**PLEASE READ CAREFULLY –  
Important Product Safety Notice Follow Up**

Following our Notice dated February 27, 2014, regarding our Honeywell Residential (Elevator) Door Interlock (RDI) Switches that contain a plastic cam, and all of our RDI2 Elevator Door Interlock Switches (collectively, the “Affected Products”), we have had conversations with many of our customers regarding the return process.

# Cam Replacement Instructions for the Relialign™ RDI Series Residential Door Interlock

FIGURE 1. INTERLOCK CAM LOCATION (for reference only)

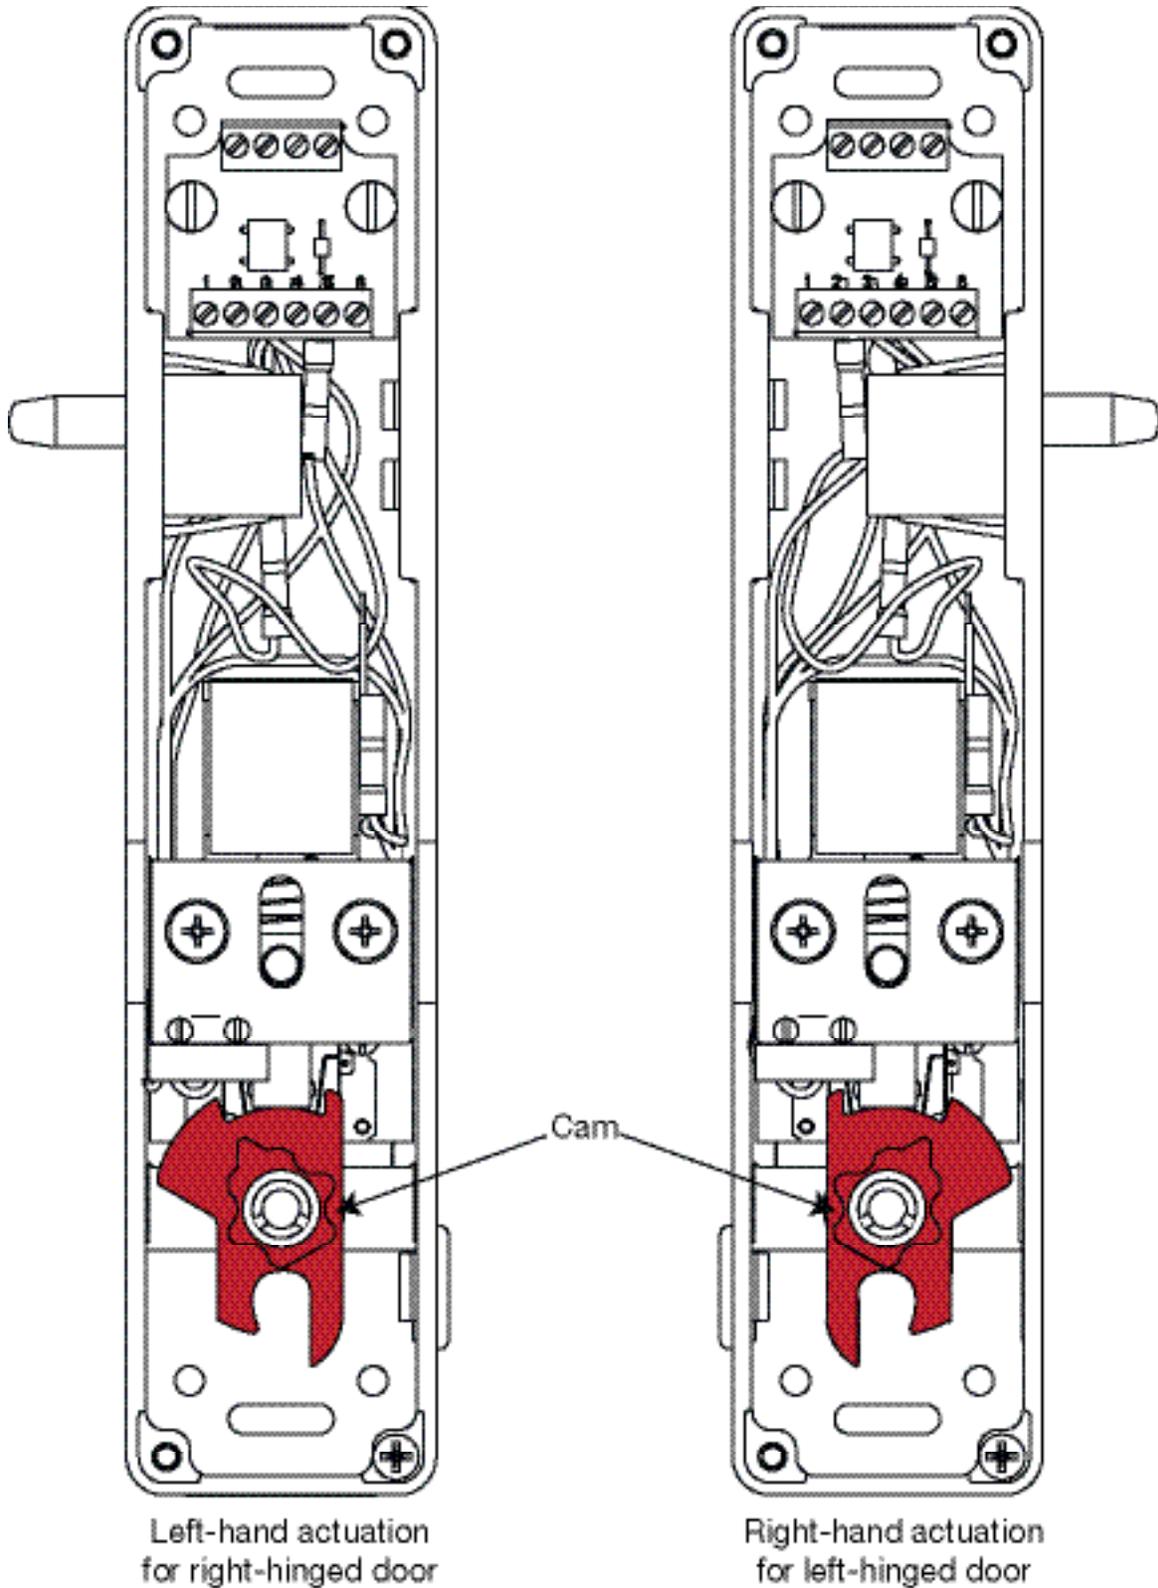
This will remove the plastic cam and replace it with the metal cam.

4. Make a note of the orientation of the cam. The opening of the cam should be directed toward the landing door. It is important that you install the new metal cam in the correct orientation.

5. Remove the plastic cam by rotating it toward the elevator car. When the arrow on the cam is pointing up, you will be able to pull the cam off the shaft.
6. Ensure the ball detents are not in contact with the cam shaft. If they are, the cam cannot be fully inserted and you must push them back into the housing using a small screwdriver.

7. Insert new metal cam in the same orientation as noted in step 4. To start the insertion, make sure the arrow on the cam is pointing toward the center of the unit (toward the solenoid).

## RDI Cam Replacement Kit

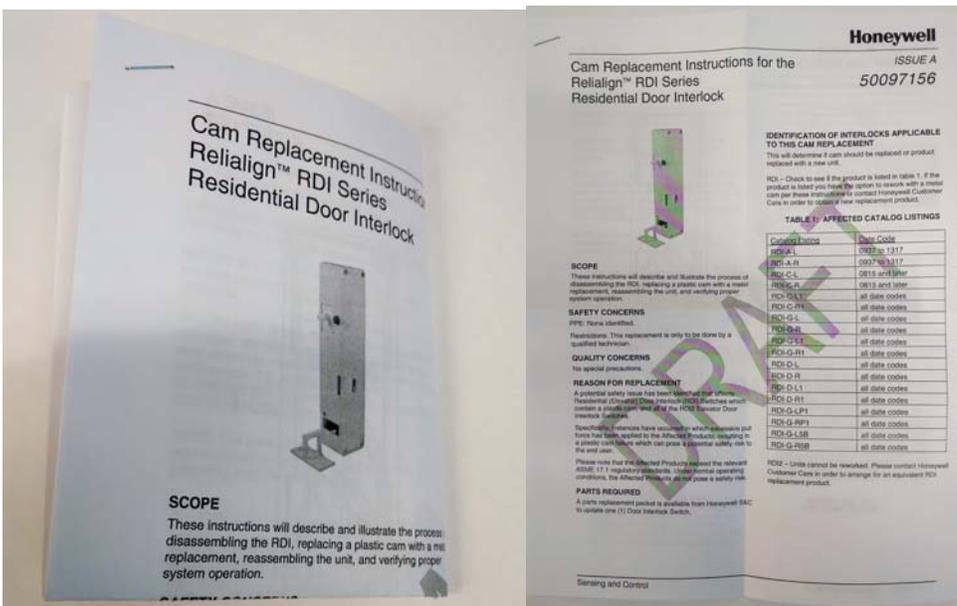
New cam identified with a red dot in the cavity ID location
